PIC16C74A Rev. A Silicon Errata Sheet

The PIC16C74A (Rev. A) parts you have received conform functionally to the Device Data Sheet (DS30390E), except for the anomalies described below.

FIGURE 1: SCK PULSE VARIATION USING TIMER2/2

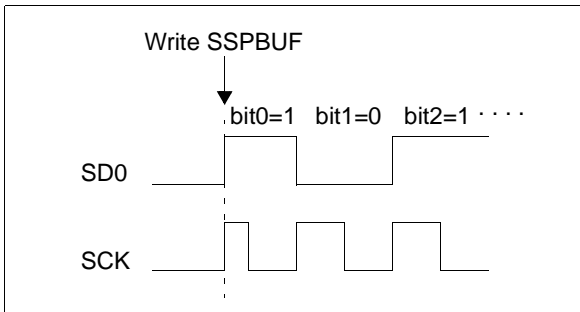
4. Module: SSP (SPI Mode)

When the SPI is using Timer2/2 as the clock source, a shorter than expected SCK pulse may occur on the first bit of the transmitted/received data (Figure 1).

To avoid producing the short pulse, turn off Timer2 and clear the TMR2 register, load the SSPBUF with the data to transmit, and then turn Timer2 back on. Refer to Example 1 for sample code.

FIGURE 1: WRITES TO TIMER1 (EXTERNAL CLOCK/OSCILLATOR MODE)

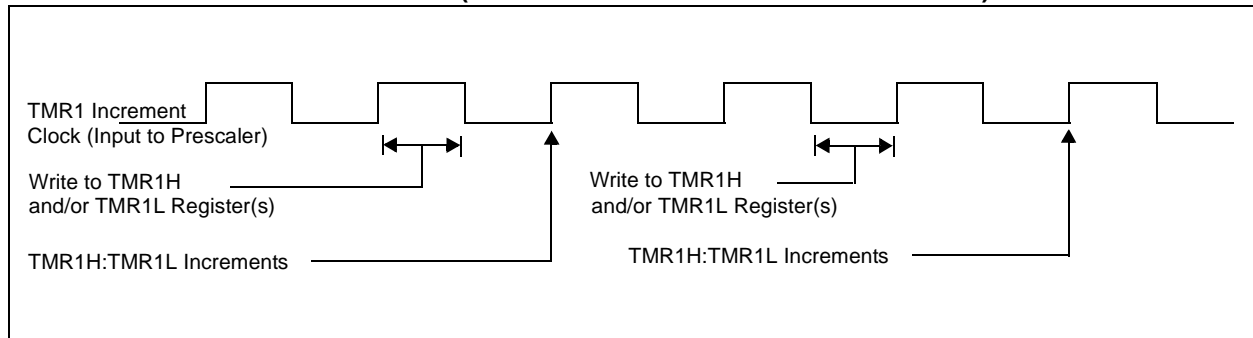
The operation of Timer1 needs some clarification when the timer registers are written when the TMR1ON bit is set.

The internal clock signal that is the input to the TMR1 prescaler affects the incrementing of Timer1 (TMR1H:TMR1L registers and the Timer1 prescaler). When the Timer1 registers are NOT written, the Timer1 will increment on the rising edge of the TMR1 increment clock.

When the TMR1H and/or TMR1L registers are written while this clock is high, TMR1 will increment on the next rising edge of this clock.

When the TMR1H and/or TMR1L registers are written while this clock is low, TMR1 will not increment on the next rising edge of this clock, but must first have a falling clock and the rising clock, for TMR1 to increment.

Figure 1 shows the two cases of writes to the TMR1H and/or TMR1L registers. Due to the V_{IH} and V_{IL} thresholds on the oscillator/clock pins, external Timer1 oscillator components, and external clock frequency, the Timer1 increment clock may not be of a 50% duty cycle.

The TMR1 increment clock is out of phase of the T1OSO/T1CKI pin by a small propagation delay.
